Patent No.: US 7,151,218 B2

For: ELECTRICAL
TERMINATION
COMPONENT BRACKET

REQUEST FOR CERTIFICATE OF CORRECTION OF PATENT

FIG. 2

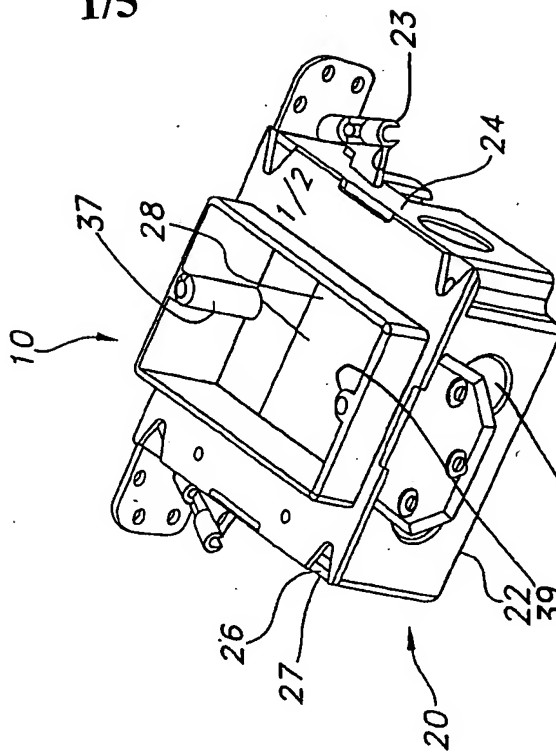
In Figure 2, previously omitted elements 21, 23, 37, and 39 have been added.

In Figure 2, previously omitted elements 21, 23, 37, and 39 have been added.

FIG. 1

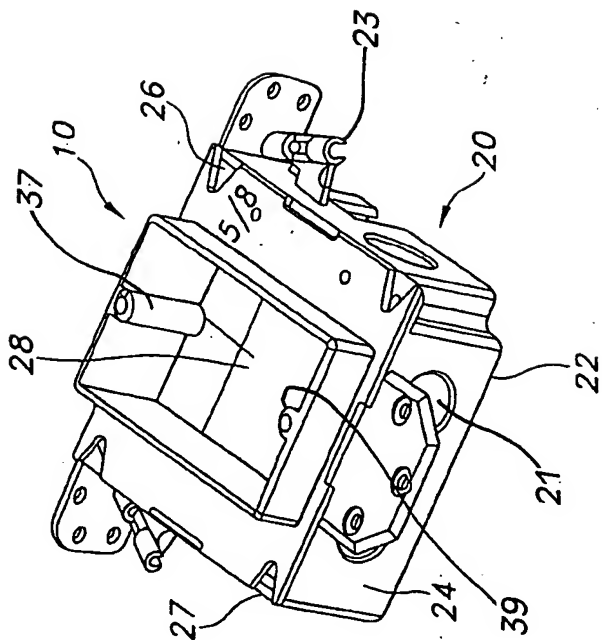
In Figure 1, previously omitted elements 21, 23, 37, and 39 have been added.

In Figure 1, previously omitted elements 21, 23, 37, and 39 have been added.

FIG. 5

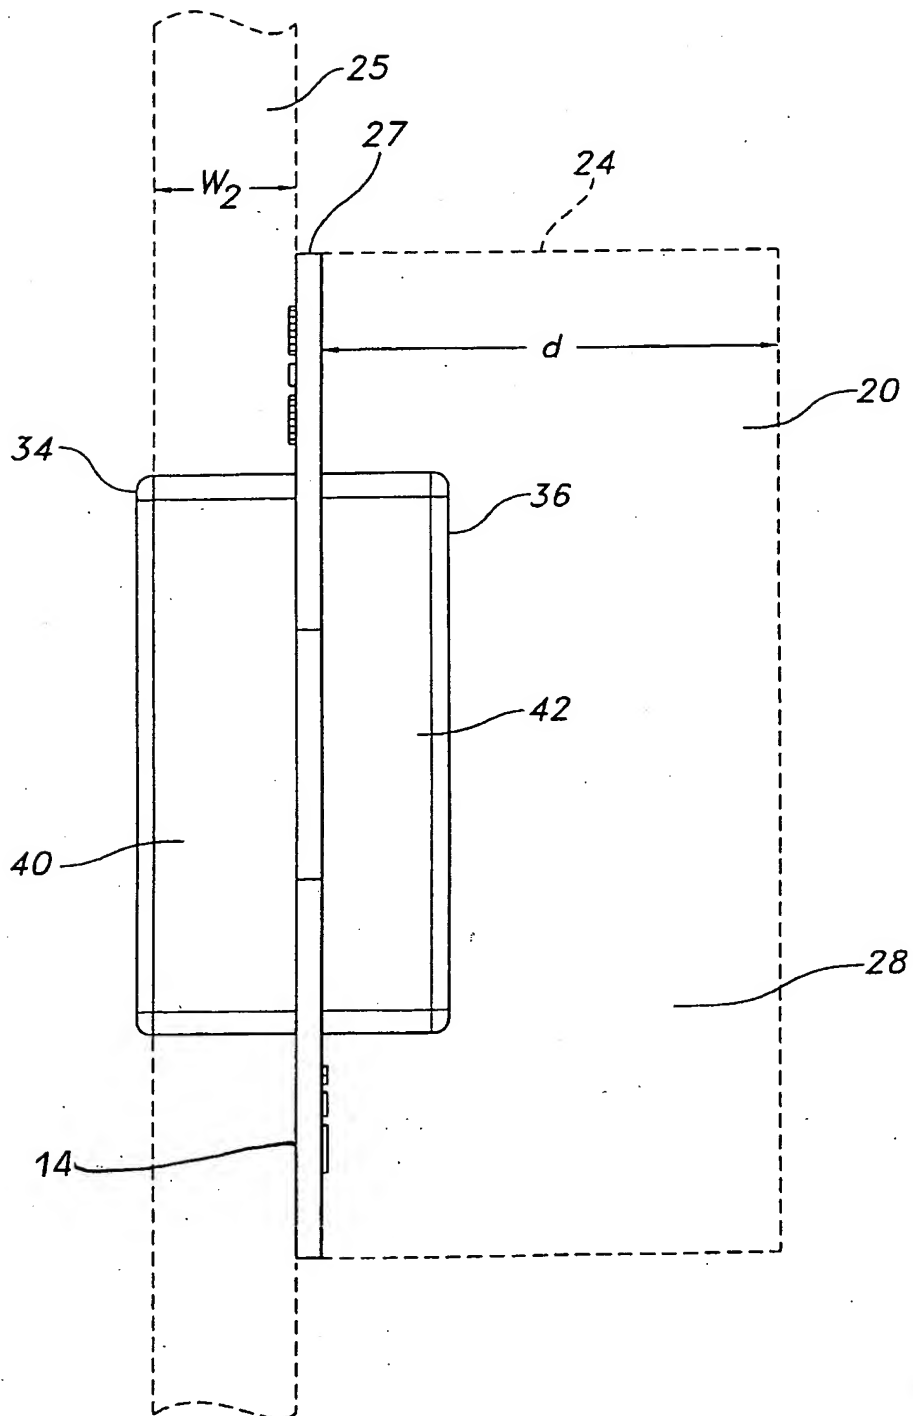
In Figure 5, previously omitted element 14 was added.

In Figure 5, previously omitted element 14 was added.

FIG. 6

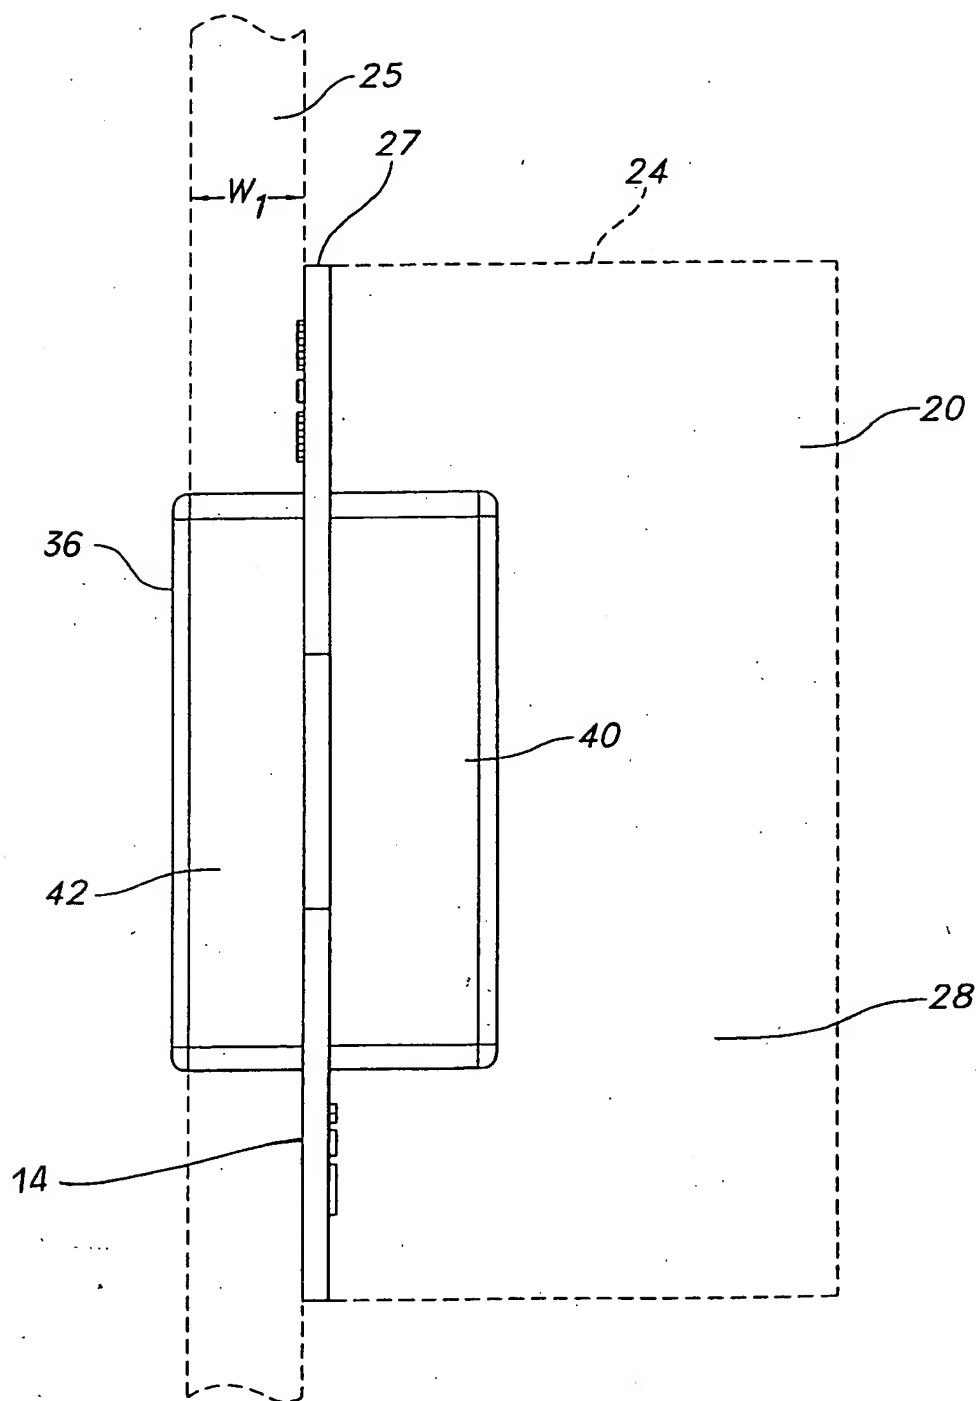
In Figure 6, previously omitted element 14 was added. Also, element "34" was replaced with element --36--.

In Figure 6, previously omitted element 14 was added. Also, element "34" was replaced with element --36--.
